19 February 2026

RE: Flooding Response to DPHI Request for Additional Information regarding the Brewongle Solar Farm (SSD-64834490)

Figure 1 (Modified from Figure B12 in SWIA)
Flood Afflux - Probable Maximum Flood (PMF) Change in Peak Flood Depth

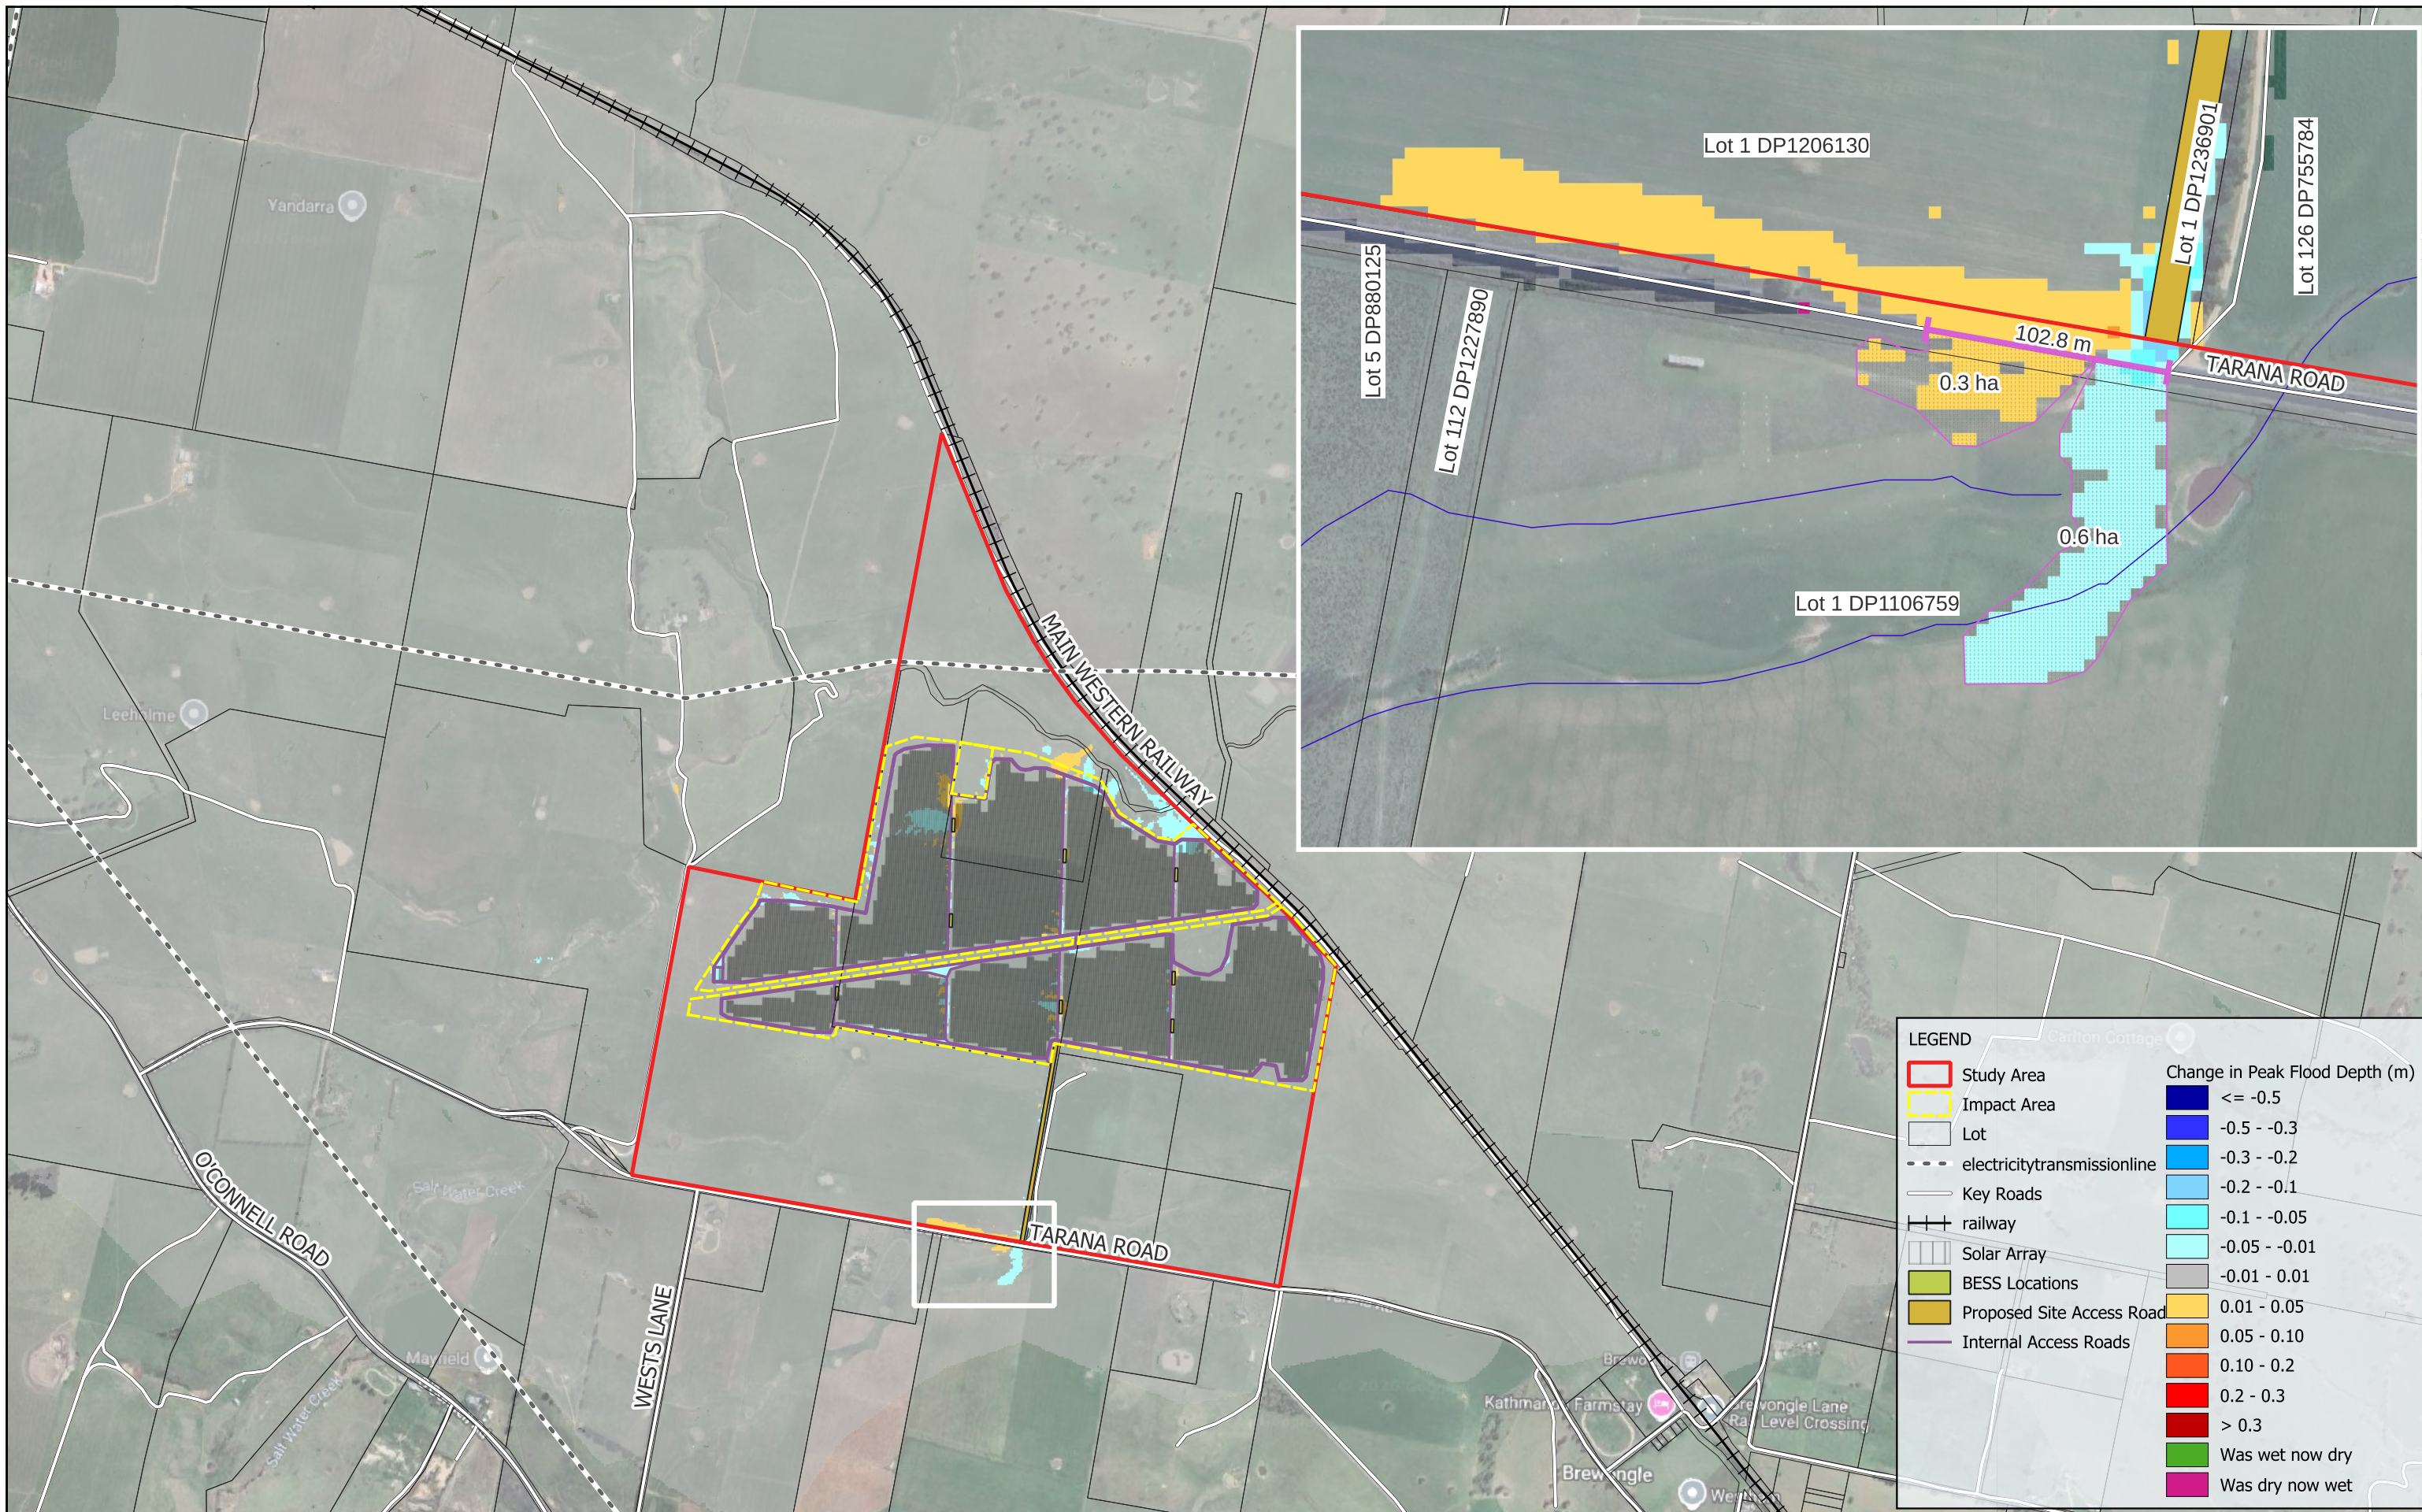
- *Details of measures proposed to avoid or mitigate off-site flood impacts.*
- *Clarify the off site flood depth increases shown in Figure B12, including:*
 - *Whether the relevant landowner/council has been consulted – to be addressed by lead EIS consultant.*
 - *What the affected area comprises.*
 - *How impacts would be mitigated.*

Figure B12 in the *Brewongle Solar Farm SWIA* (Engeny, 2025) presents the change in peak flood depth results for a Probable Maximum Flood (PMF) event. As identified in DPHI's response, Figure B12 indicates changes in flood depths outside of the Study Area, that is off-site impacts, in the PMF are expected adjacent to the intersection of Tarana Road with the proposed site access road, extending to the downstream property (Lot 1, DP1106759). The extent of off-site impacts is also shown on Figure 1 and include:

- Approximately a 100 m stretch of Tarana Road with increases in flood depth of up to 30 mm (refer to Figure 2). It is noted that flood depths along Tarana Road in the impacted area reach up to approximately 680 mm under baseline conditions (Figure A5 of the SWIA (Engeny, 2025)), which would already result in restricted access. Similarly, Figure A15 and Figure B9 in the SWIA show Flood Hazard in the H5 category under both baseline and developed conditions, with negligible change to the impacted section due to the development (Figure 3). The *Australia Disaster Resilience Handbook 7 – Managing the Floodplain: A Guide to Best Practice in Flood Risk Management in Australia* (AIDR, 2017) defines a H5 hazard category as unsafe for vehicles and people. The additional increase (30 mm) is therefore unlikely to cause additional access impacts or risks as the road is already impassable during the PMF event.

- Localised area (<0.3 ha) of downstream property (Lot 1, DP1106759) with increases in flood depth of up to 30 mm. The impacted area comprises of an access road. It does not appear to be a primary residential driveway. Figure A5 of the SWIA (Engeny, 2025) indicates that the entrance of this access road is expected to be inundated to depths greater than 500 mm, with a flood hazard category of H5 (unsafe for vehicles and people) under baseline conditions. Access in the impacted area would therefore already be restricted, and the additional increase (<30 mm) is therefore unlikely to cause additional risks as the access road is already impassable during the PMF event.

- Localised area (~0.6 ha) of downstream property (Lot 1, DP1106759) with decreases in flood depths of up to 80 mm. The impacted area is largely associated with an existing flow path, downstream of a farm dam. Changes to flow depths are considered minor.
